REMARKS

Amendments to the Drawings:

FIG. 1

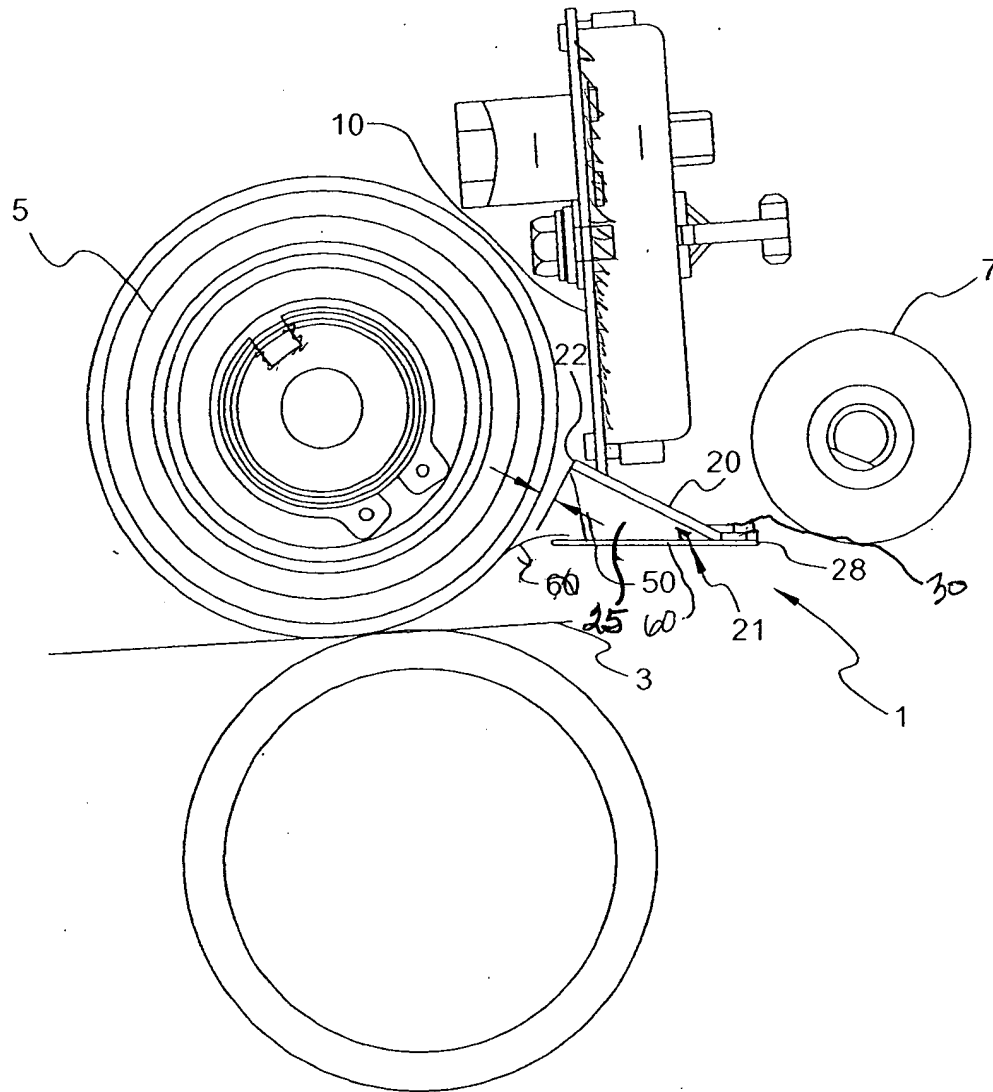
FIGs. 1-4 have been corrected based on the Examiner's recommendation and some minor changes made as indicated. These changes include the line from "50" in FIG. 1, the line to "22" in FIG. 4, the lines in FIGs. 1 and 3, and FIGs. 2 and 4 which the Applicants now believe clearly show the "distance between the terminal edge and the base plate decrease or the distance from said skive plate central portion", claimed in claim 1, and "the gap" claimed in claim 9.

FIG. 3

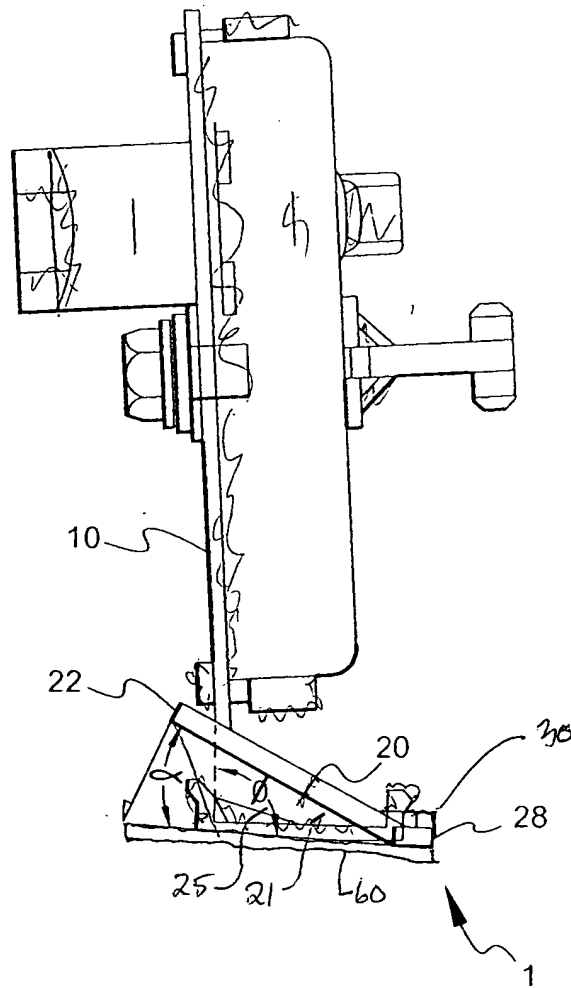
Claims 14, 23 and 24 were rejected as being anticipated by Morganti 6,295,436 but Morganti does not have an air passage slot between the skive plate and the base plate as shown in FIG. 4 as #40. Morganti only has a gap between the roller and the terminal edge. Thus independent claim 14 is allowable, as are all claims depending from it (claims 15-26).
